Report to Sydney Central City Planning Panel

SCCPP reference	PPSSCC-340																	
DA No.	53/2022																	
Date of receipt	21 January 2022																	
Proposal	Construction of seven 10-13 storey buildings comprising 620 residential units, child care centre for 110 children, 1,735sqm of 17 neighbourhood retail shops and 864 basement car parking spaces; publicly accessible open spaces and through site links; roads; landscaping; and tree removal.																	
Street address	263-273 Pennant Hills Road and 18 Shirley Street Carlingford																	
Property Description

Recommendation	Refusal
Report by	Bianca Lewis, Executive Planner

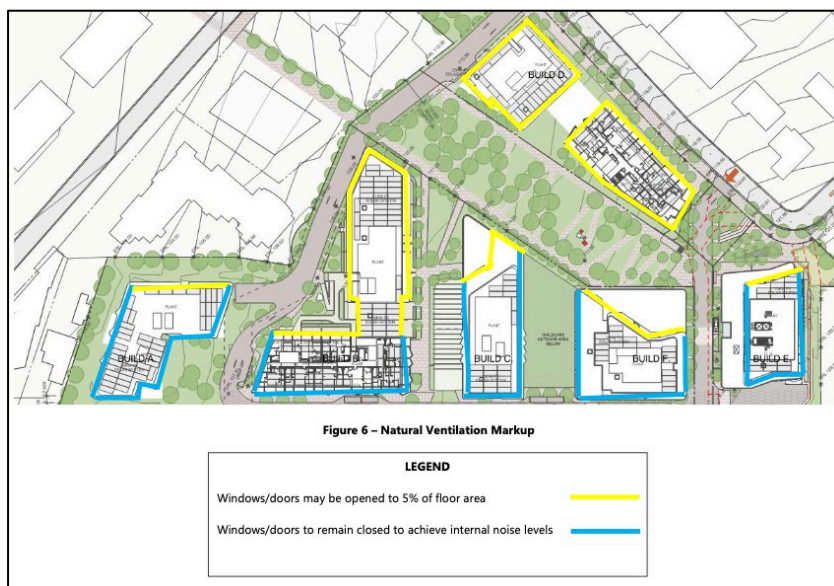
Due to the site's size (>1,500sqm) the ADG design guidance recommends 15% of the site as deep soil. Currently the deep soil is located in poor locations and fragmented across the site, in particular at the southwestern part of the site (around Building A) and between Buildings A and B and B and C. In accordance with ADG Design Guidance basements should be consolidated beneath building footprints. Basement car park encroach into the setbacks along Shirley Street, alongside Central Park and on Pennant Hills Road. Council Officers consider that at a minimum the proposed development should locate basement car parks beneath buildings in order to provide greater amount of and consolidated deep soil zones.

Figure 10: Site Survey Plan (Source FK Drawing DA-003). Council Officer red arrows indicating location of easement.

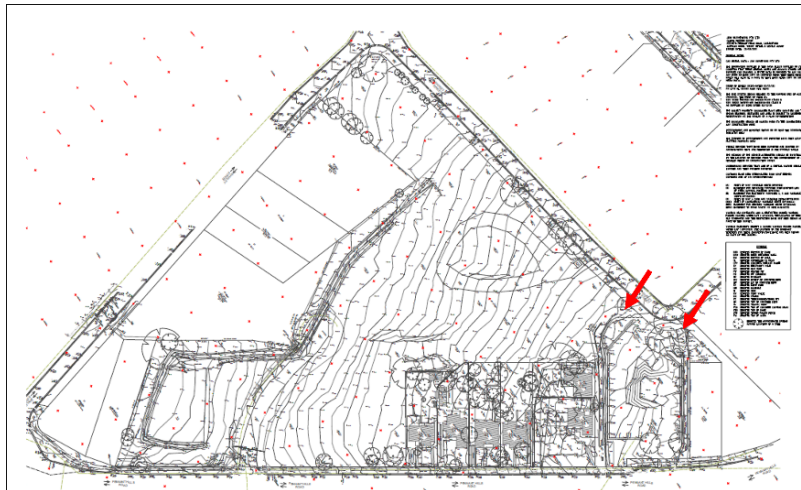
The subject site contains underground electricity cables within concrete channels, which run in a northwest to southeast direction from Shirley Street to Pennant Hills Road (refer Figure 10 below). In accordance with Clause 2.48 of the SEPP (Transport and Infrastructure) 2021, the proposal was referred to Ausgrid.

Ausgrid raised concerns in relation buildings or structures, or parts thereof constructed may encroach the easement. In response to their referral advice, Council Officer sought to clarify these concerns.

Correspondence from Ausgrid on 22 November 2022 sought clarification in relation to a proposed cable bridge to support the Ausgrid cables which was included in the former development consent, however the current application does not. This bridge was to allow for a driveway beneath the cables which would connect between two buildings. The applicant has subsequently clarified that the former DA removed the bridge as part of a modification and that the current application does not propose to provide the bridge. At the time of writing this report no response has been provided by Ausgrid as to the acceptability of the development proposal

Figure 13. Proposed breach of height limit (red shading represents that area below the 27m or 33m height standard). Source: Amended Clause 4.6 Variation Building Height, Planning Ingenuity 13 October 2022

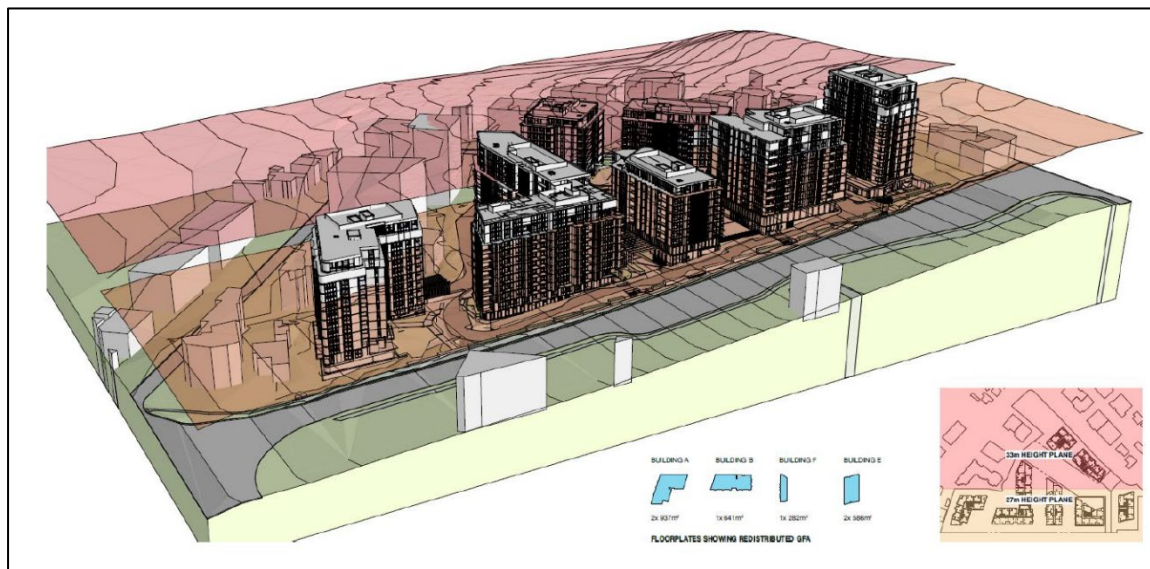
The proposal does not comply with the Clause 4.3 ‘Height of Buildings’ development standard and as outlined in Figure 2 above, and as such the applicant has submitted a request to vary the height standard under Clause 4.6 of the Parramatta (former The Hills) 2012.

Figure 16: 27 & 29 Lloyds Avenue (outlined in blue) overall land use zoning map (Parramatta (Former The Hills) LEP 2012)

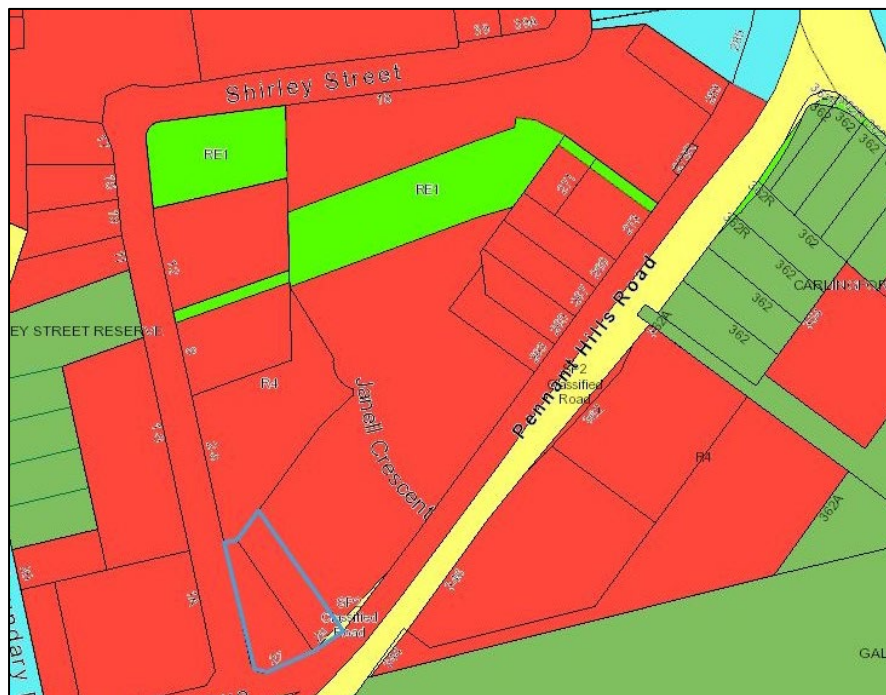
As identified in Figure 16, 27 and 29 Lloyds Avenue are located directly to the south of the subject site and in the Parramatta (The Former Hills) LEP 2021 the sites are zoned R4 High Density Development, with a height of building 27m and FSR of 2.3:1. 27 Lloyds Avenue contains the Carlingford Uniting Church ~988sqm in area, and 29 Lloyds Avenue is a single dwelling house and is ~946sqm in area. The adjacent sites at 2-6 Shirley Street and 8 Shirley Street are strata developments.

Notwithstanding, the proposal has not adequately demonstrated that it does not result in the isolation of adjoining lots at 27 and 29 Lloyds Avenue, so that they are capable of multi dwelling

Figure 17: Proposed shadow at 11am on adjoining properties (source FK Shadow Diagrams DA-402)

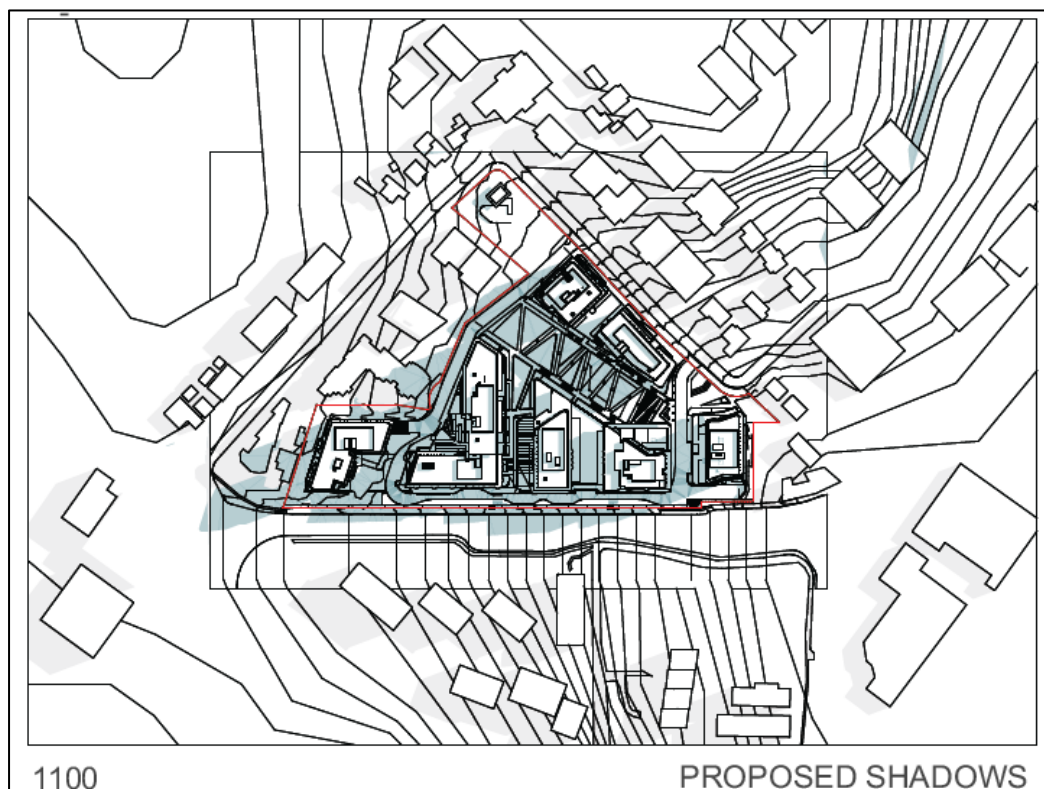
- The proposal will result in additional overshadowing on 2-6 Shirley Street’ an existing residential units complex and on its communal open space (including outdoor pool) between 9am and 12pm, noting additional overshadowing to the rear of the property at 12pm.
- The proposal will result in additional overshadowing on adjacent single dwelling at 29 Lloyds Avenue and 27 Lloyds Avenue (Church) between 9am and 12pm, with some overshadowing at 12pm. These sites are zoned R4 and have development potential (refer detail above).

It is noted that the shadow analysis submitted does not provide a comparison of the impact of the height variation on the overshadowing impact on adjoining properties.

Additional overshadowing due to the development will occur to residential properties opposite the site at 346 and 362 Pennant Hill Road between 1pm and 3pm. Additional overshadowing will be created by the development between 1pm and 3pm. In these instances, the DCP requirements are met as solar access is maintained for 4 hours to these properties.
